REVIEWED
By Nancy L. Avery at 3:41 pm, Feb 27, 2015

BRISTOL
BRF 021-1(29)
VT ROUTE 116 STA
ADDISON, VT
TRAFFIC / SIGNS
PLAN
1

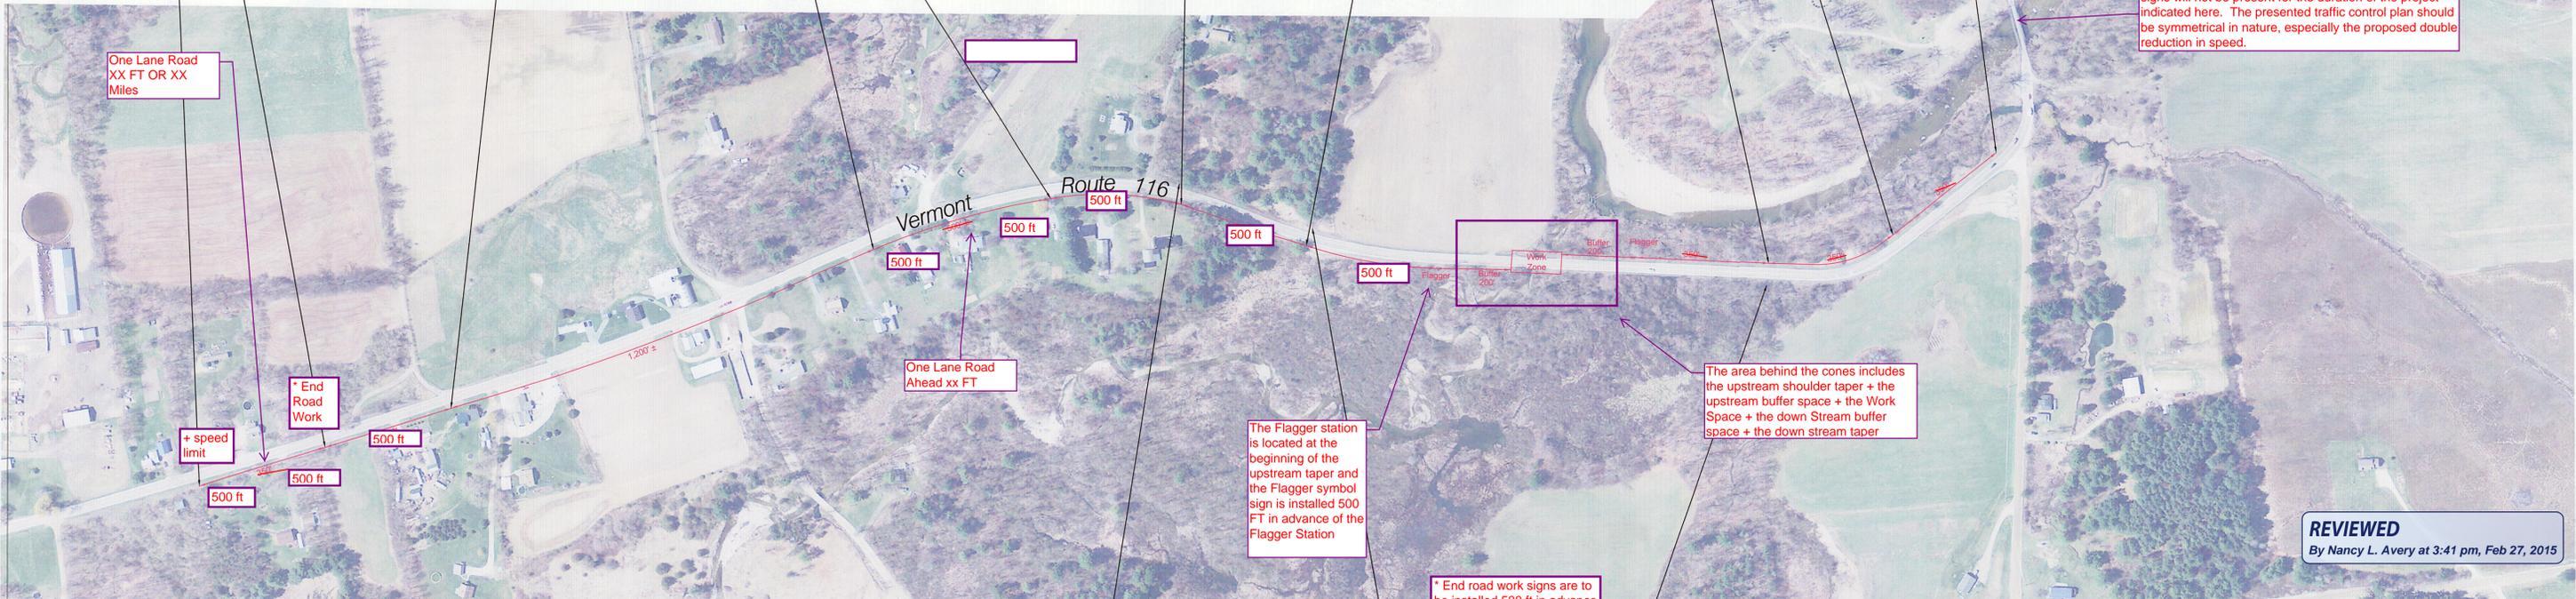
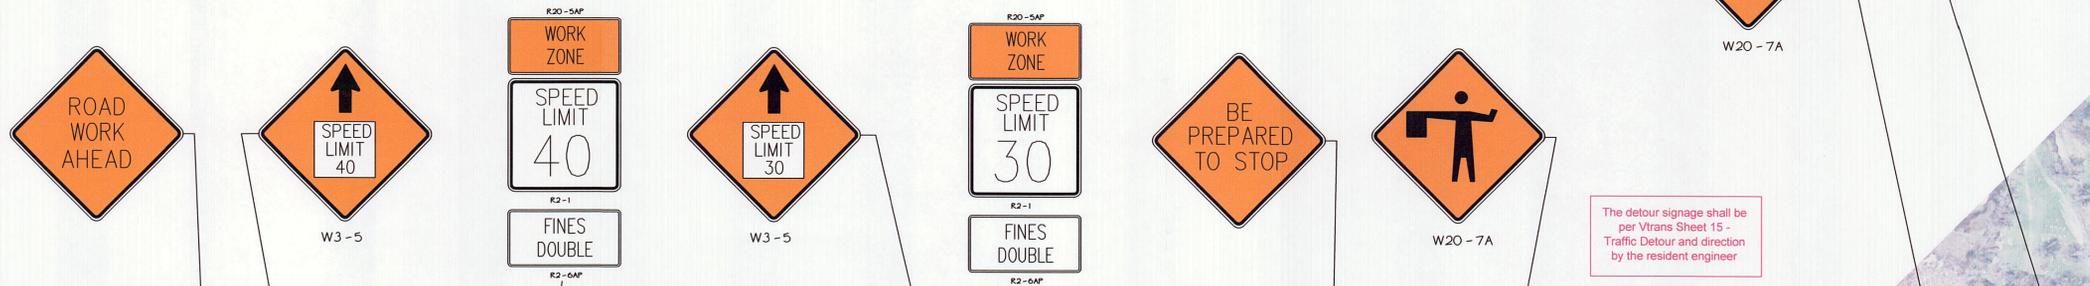
Based on the nature of the road type a consistent 500 ft sign spacing should be used for the entire project.

What is the TCP for when the bridge is closed at the immediate project site?

Is this sign warranted? Or is this something that is currently installed for the adjacent bridge project? Has the reverse turn been ball banked to verify that the 20 mph advisory plaque is warranted? If this is to be used in conjunction with the construction project it should be and orange sign with black border and symbol.

This bridge project is wrapping up and the work zone signs will not be present for the duration of the project indicated here. The presented traffic control plan should be symmetrical in nature, especially the proposed double reduction in speed.

The detour signage shall be per VTRANS Sheet 15 - Traffic Detour and direction by the resident engineer

The area behind the cones includes the upstream shoulder taper + the upstream buffer space + the Work Space + the down Stream buffer space + the down stream taper

The Flagger station is located at the beginning of the upstream taper and the Flagger symbol sign is installed 500 FT in advance of the Flagger Station

* End road work signs are to be installed 500 ft in advance and across from the Initial Road Work Ahead sign.

+ The speed limit sign should be installed 500 ft after the End Road Work sign to return traffic to the posted speed limit for the highway.
